ADDENDUM NO. 1

Date: May 25, 2011
To: Contractors
From: Brian Bales - Project Manager
Reference: Rooftop Solar Array – Miller Campus
Salt Lake Community College – Sandy, Utah
DFCM Project No. 11018680
Subject: **Addendum No. 1**

Addendum 001

project:	DFCM SLCC Solar Project	project no:	11010
date:	2011-05-25	no. pages:	2
owner:	DFCM		
contractor:			
bid date:	2011-06-01	bid time:	4:00 pm

System No. C-AJ-1463

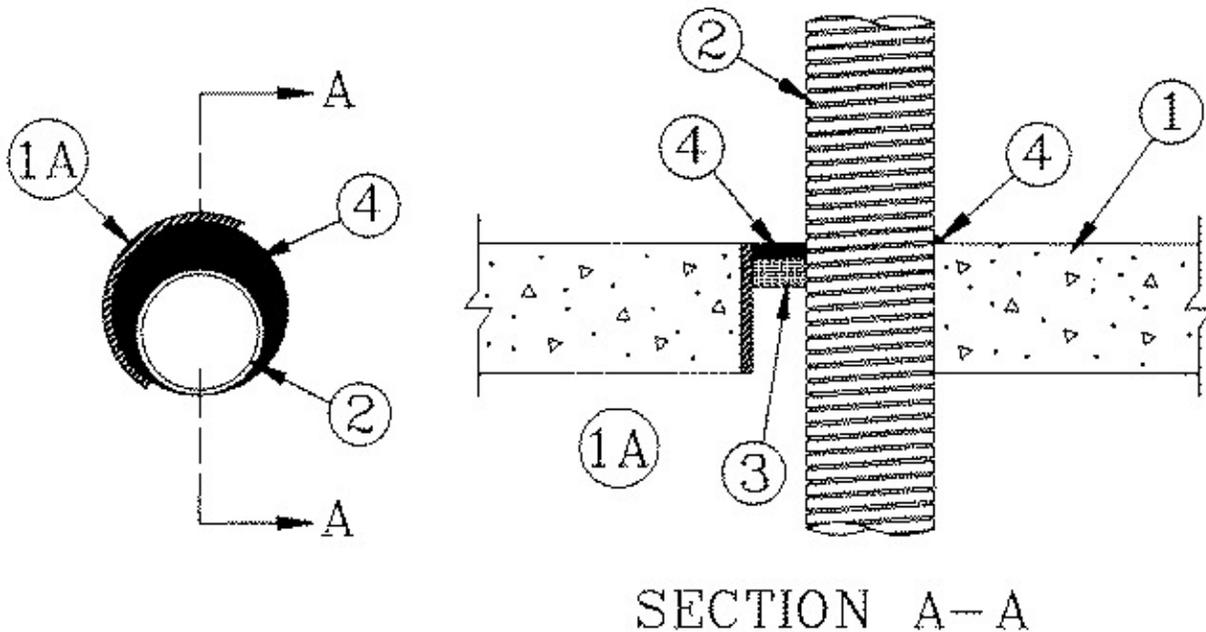
Item	Detail No	Description
1.1	XHEZ C-AJ-1463	Note all penetrations through the concrete wall on the north side of the automotive bay must meet rated penetration requirements, per the attached UL Rated Penetration Detail XHEZ C-AJ-1463.

1. **Floor or Wall Assembly** — Min 4-1/2 in. thick lightweight or normal weight (100-150 pcf) concrete. Wall may also be constructed of any UL Classified **Concrete Blocks***. Diam of circular through opening in floor or wall assembly to be 3/4 in. to 1-1/2 in. larger than diam of flexible metal conduit (Item 2) installed in through opening. Max diam of opening is 6 in.

2. **Through Penetrating Product*** — Nom 4 in. diam (or smaller) aluminum **Flexible Metal Conduit#** or nom 3/4 in. diam (or smaller) steel **Flexible Metal Conduit#**. Max one conduit per through opening. Max annular space between conduit and edge of through opening not to exceed 1-1/2 in. Min annular space between conduit and edge of through opening is zero in. (point contact). When aluminum conduit is used, F Rating is 2 Hr. When steel conduit is used, F Rating is 3 hr. Flexible metal conduit to be rigidly supported on both sides of floor or wall assembly.

3. **Packing Material** — Polyethylene backer rod or min 1 in. thickness of mineral wool batt insulation firmly packed into opening as a permanent form. Packing material to be recessed min 1/2 in. from top surface of floor or from both surfaces of wall.

4. **Fill, Void or Cavity Material*—Caulk** — Applied to fill the annular space around the flexible metal conduit. In floors, a min 1/2 in. depth of fill material to be installed flush with top surface of floor. In walls, a min 1/2 in. depth of fill material to be installed flush with wall surface on both sides of wall assembly. When steel sleeve is not used or is used and installed flush with floor or wall surfaces, a min 1/4 in. diam bead of caulk shall be applied to the floor on wall surface where the through penetrant is installed in point contact with the edge of the through opening.
